**RE: Smiths Creek Landfill, St. Clair County, Michigan
Independent Peer Review and Evaluation Report
CEC Project 353-805**

**SMITHS CREEK LANDFILL
INDEPENDENT ENGINEERING PEER REVIEW AND
EVALUATION OF SEPTAGE APPLICATION**

CEC Project 353-805

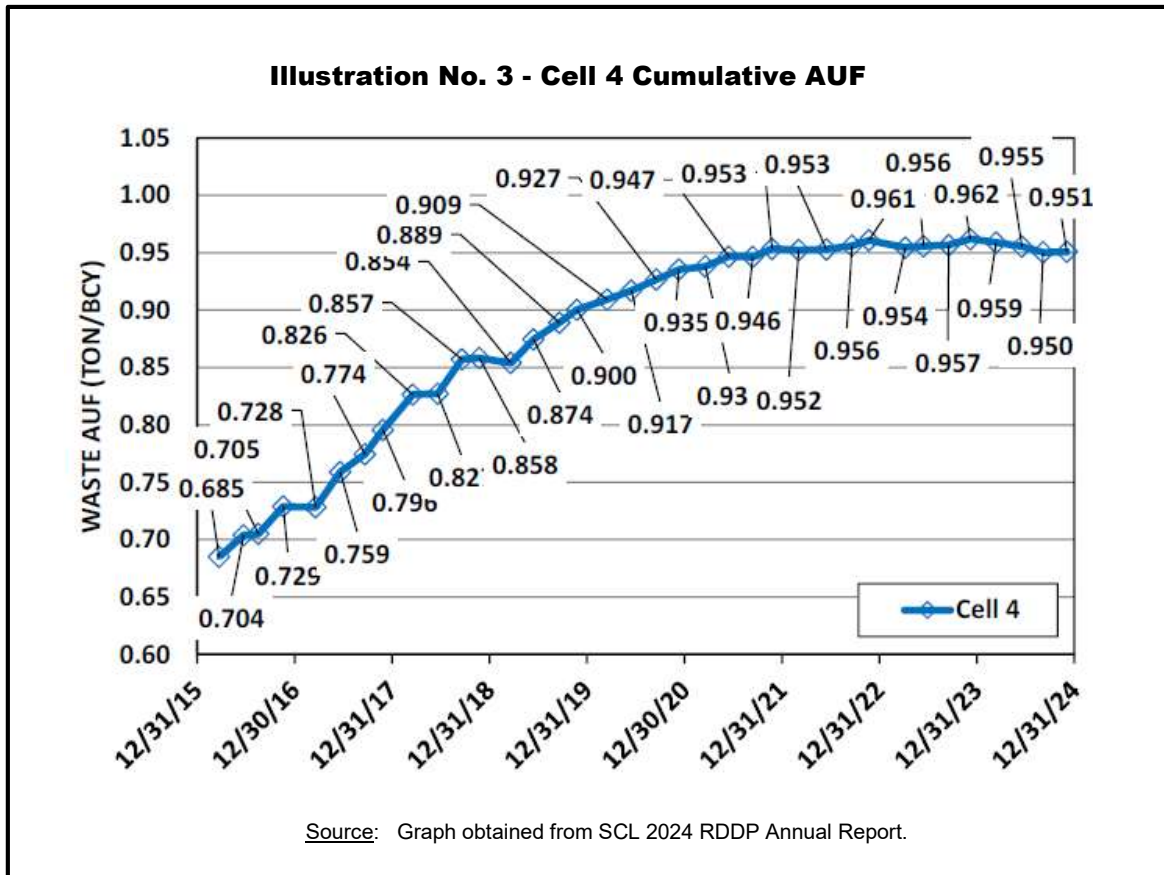
Cell 3A received 5.4 million gallons of septage, and 0.45 million gallons of leachate (92% of the added liquid was septage). Cell 3B, which has less waste than Cell 3A, received less liquid; specifically, Cell 3B received 1.6 million gallons of septage and 1.0 million gallons of leachate (62% septage). Despite the significant difference in the proportion of septage received, both cells exhibited similar increases in AUF, suggesting that septage was not more effective at enhancing settlement than leachate.

Cell 4: The graph presented as **Illustration No. 3** below was excerpted from the 2024 Annual RDDP Report. It shows high initial gains in AUF of about 9% per year and tapered to 0% per year. Cell 4 contains a commingled waste stream with MSW, C&D, and special waste all disposed of together.

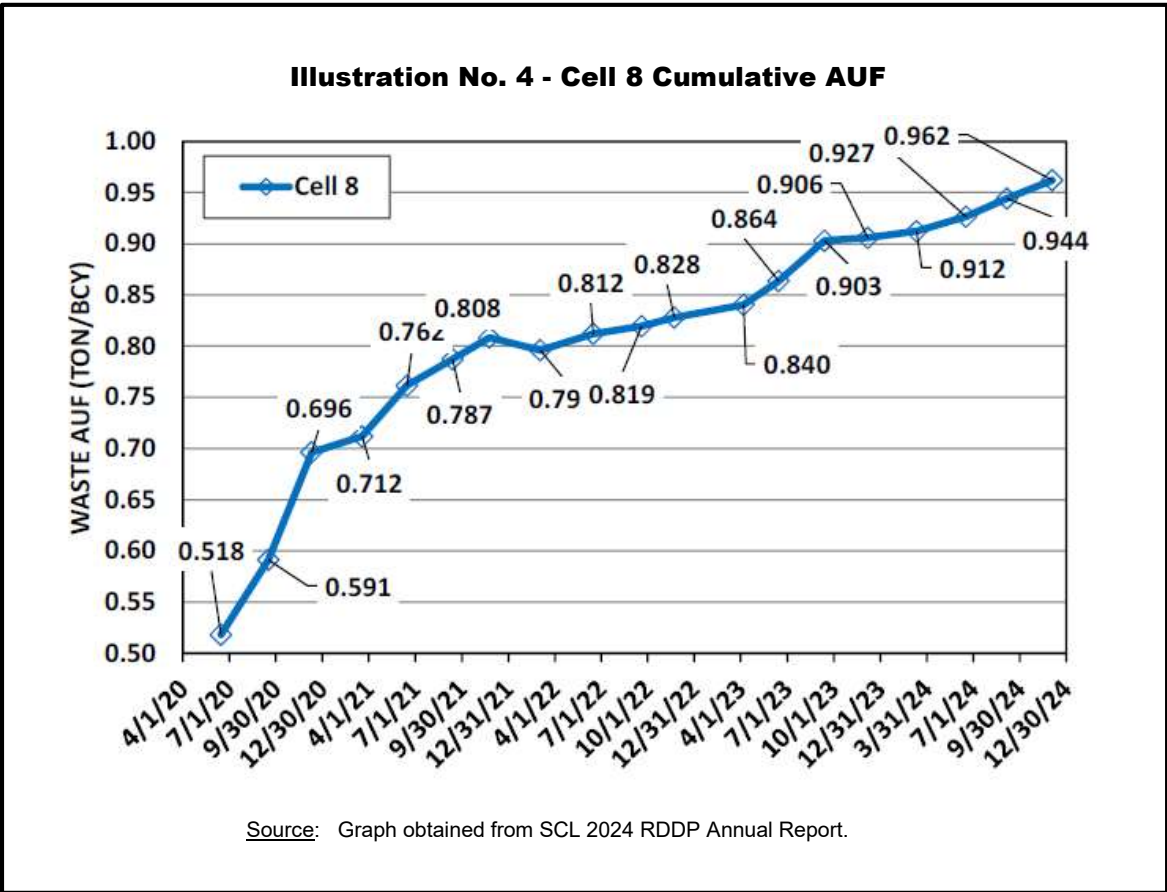
Cell 4 received approximately 4.0 million gallons of septage with no leachate recirculation (100% septage). This includes 2021–2023 when approximately 2.7 million gallons of septage were disposed of without any gain in AUF.

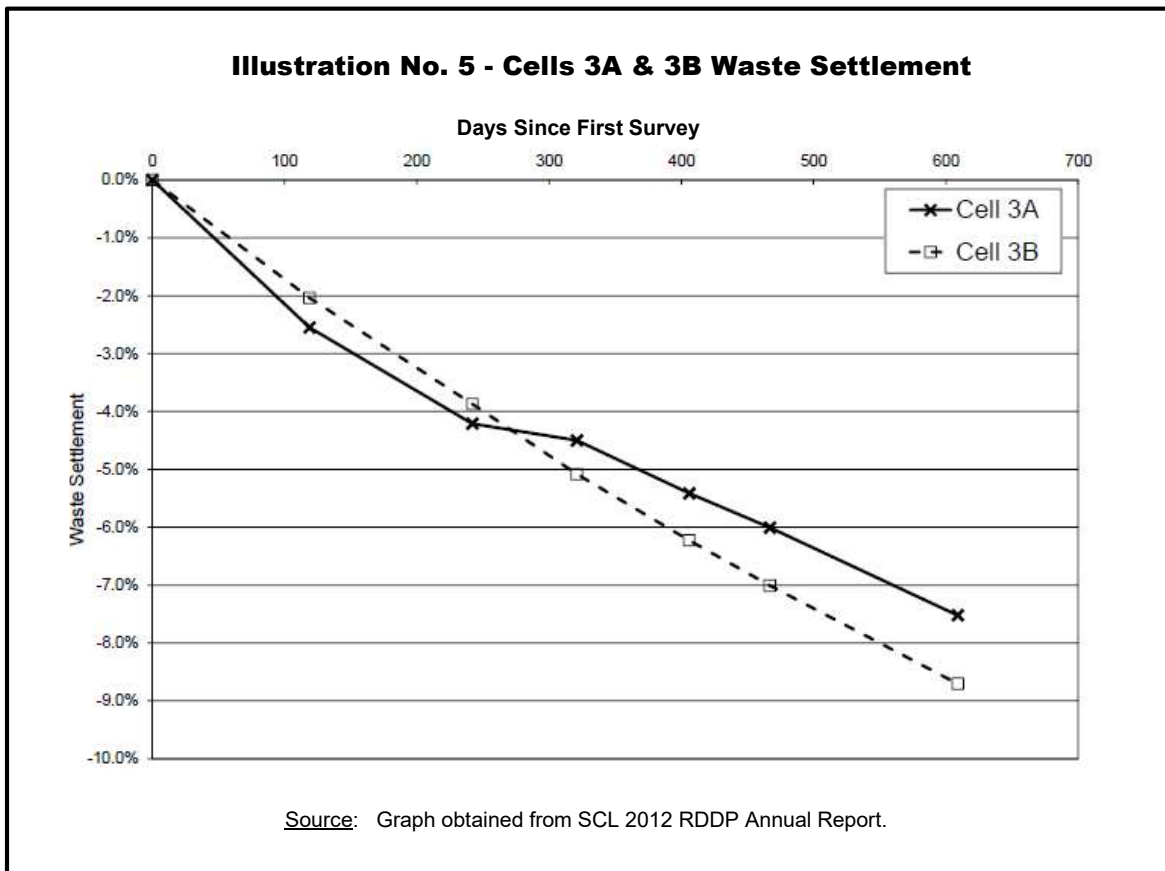
AUF, otherwise known as waste density, is expected to rapidly increase, especially as additional waste is placed over previously placed waste. In the case of Cells 3, 4, and 8, the initial densities of approximately 0.5 to 0.7 tons per cubic yard are somewhat low (typical as-compacted MSW densities range from approximately 0.7 to 0.8 tons per cubic yard) and suggest a moderate compaction effort during placement of waste in these cells. Therefore, the rapid increase in AUF with the longer-term leveling off is to be expected with, or without, added leachate or septage.

In addition, the increasing rate of AUF does not appear to be related to the quantity or proportion of septage applied in the cells. In CEC’s opinion, the AUF results presented do not support the accelerated decomposition expected in a bioreactor.

CEC'S PROPOSED MODIFICATIONS/ADDITIONS
TO CCI'S SOUTHERN LOOP EXPANSION PLAN

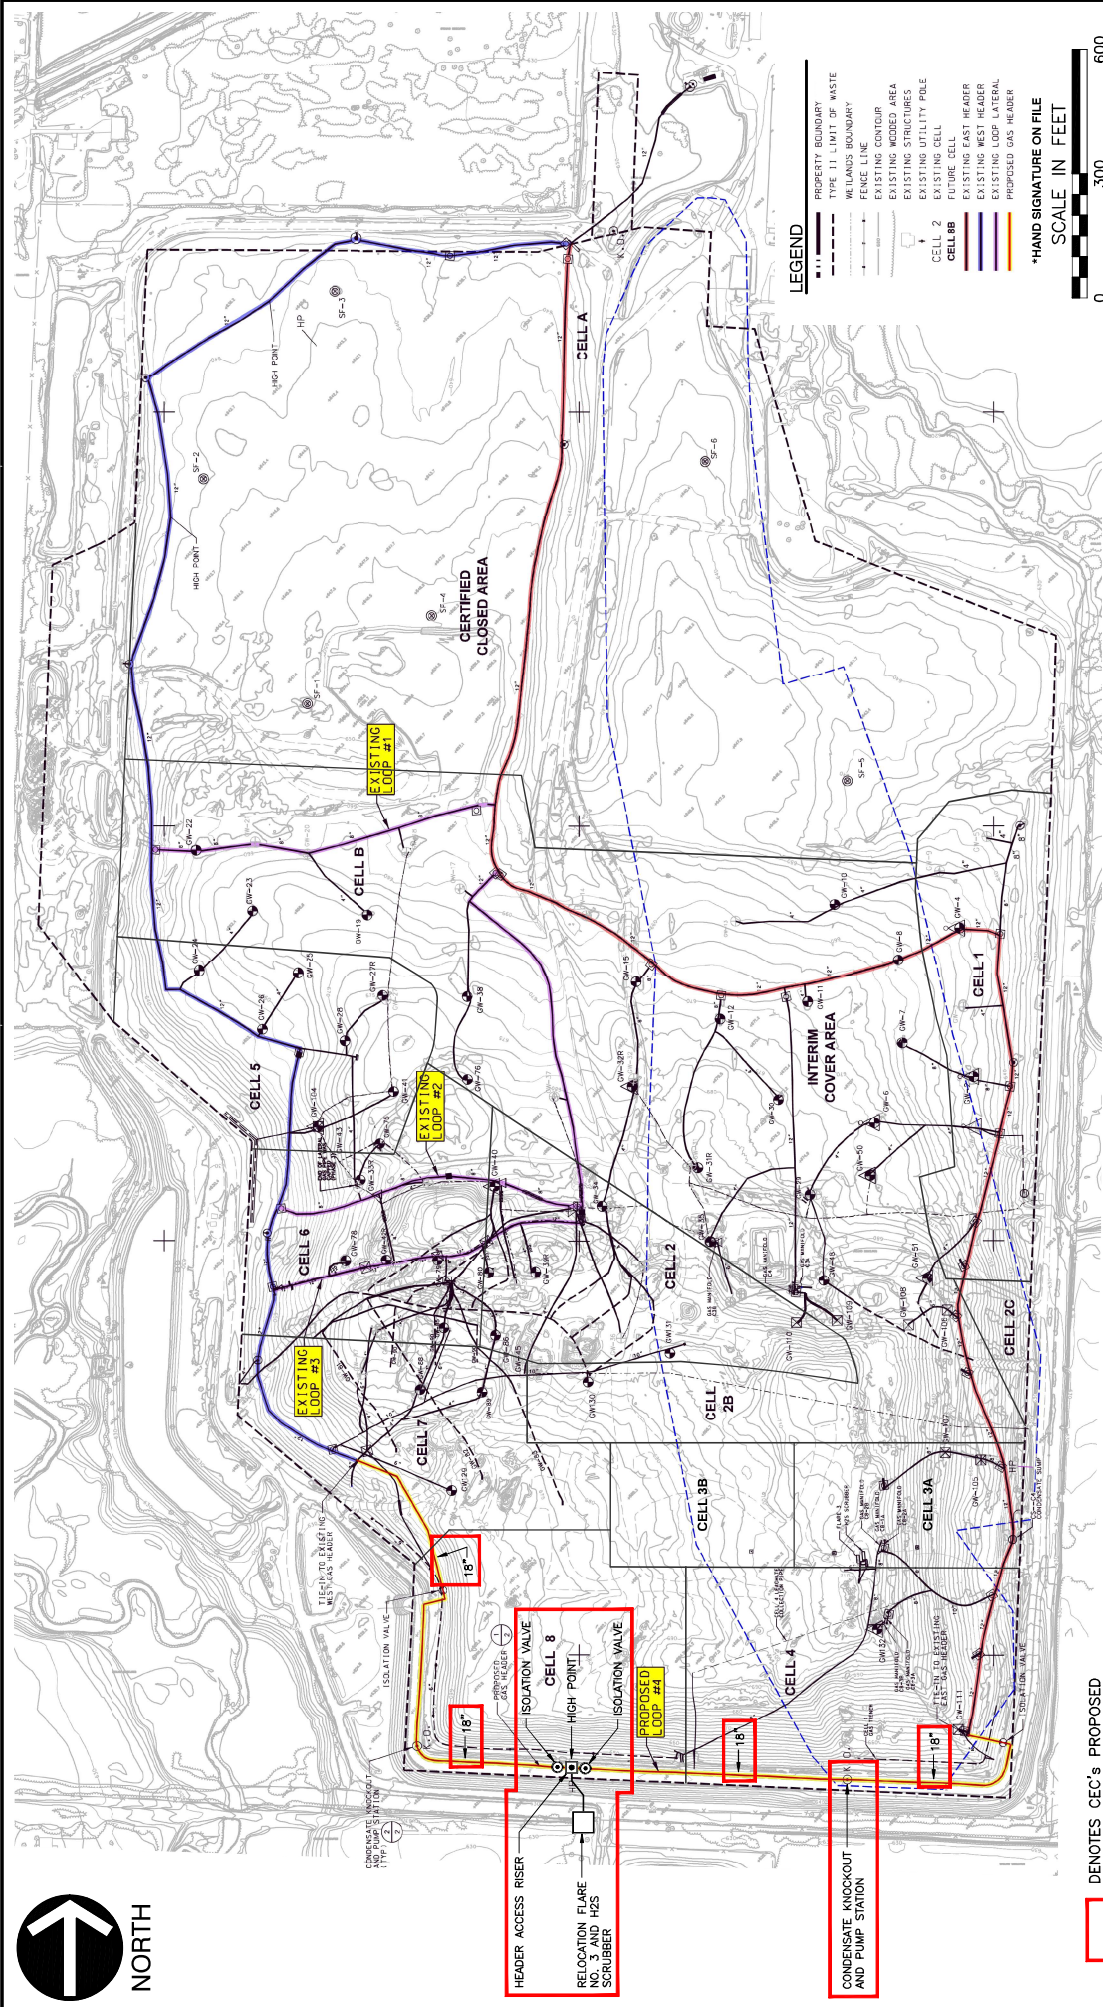
It is recommended that the proposed southern perimeter exterior vacuum header pipeline be constructed for 18-inch HDPE PE 4710 SDR 17 pipe and fittings and include in the common excavated trench a 2-inch HDPE SDR 9 compressed airline, and a 2-inch HDPE SDR 11 force main within a 4-inch HDPE SDR 17 containment pipe dual containment force main. CEC recommends enhancement of the proposed southern perimeter exterior vacuum header pipeline system included have header access risers with control valve assemblies installed every 250 feet to provide interconnection access for future expansion. It would be then possible to install manifold units at each end of a series of horizontal lateral extractors and provide the ability to apply vacuum from both ends of the horizontal lateral extractors. This would enhance vacuum application to the waste mass at both ends of horizontal lateral extractors and increase the zone of influence. Further, this would facilitate overall landfill gas extraction and prevent uncontrolled surface emissions with their associated odors.

be eventually moved to claim additional waste disposal airspace in the future. The installation of a header access riser with tee and isolation valves assembly at the high point of the proposed perimeter exterior vacuum header pipeline system would provide access and interconnection for the relocation of the Flare 3 and hydrogen sulfide equipment. CEC's proposed modifications/additions to CTI's Southern Loop Expansion Plan are presented on **Figure 4** (provided in the Figures section of this report).

Figure 5-17B Landfill Gas Production Modeling for Cell 3A

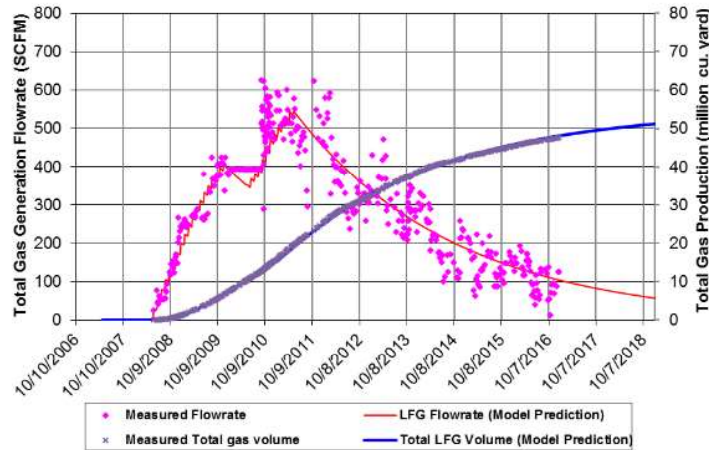
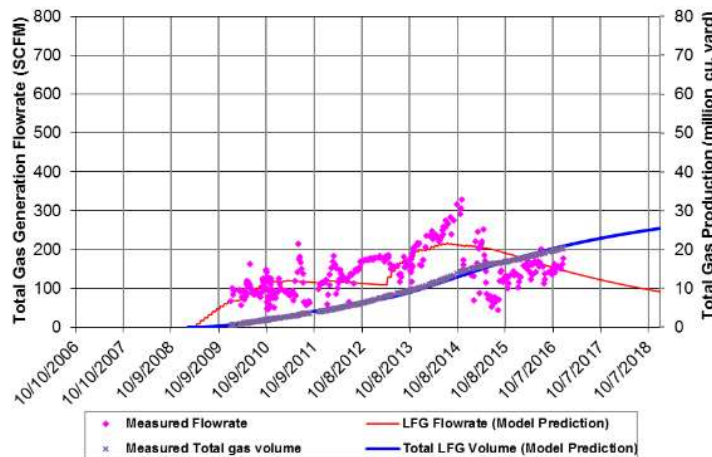
12. In 3a (septage added) $k = 0.296$, In 3b where only leachate recirculated $k = 0.082$

13. There were concerns that 3 b LFG was not accurate, so eventually, septage added to both cell 3 units, and after 2013 k was estimated as a function of the amount of septage added ($k = 0.01395S + 0.082$) until sufficient S (15 gal/ton – why???) to ~ a septage bioreactor. $15 \times 0.01392 + 0.082 = 0.29$. Ultimately Cell 3 gas modeled instead of individual test units

Correct.
